Product group:	SEMIPACK	Rev.:	0
No.:	PN20-101	Errata of SEMIPACK 4 datasheets	27 Oct 2020

Subject of change: Datasheet correction

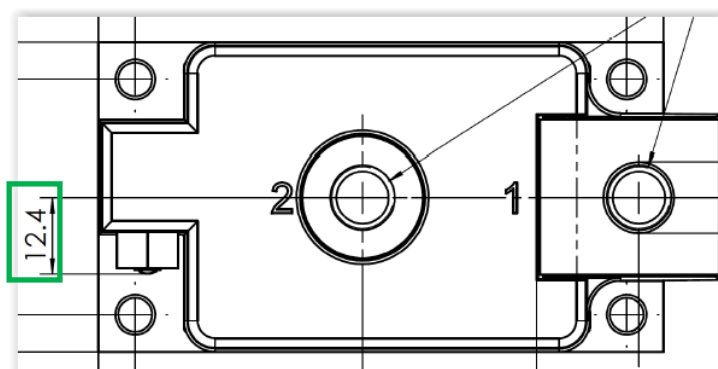
Additionally, for the thyristor types (SKET) the drawing will be adapted. The correct distance of the top of the auxiliary contact from the module length axis is 12.4 mm, while in the former drawing this distance was wrongly given as 11.5 mm.
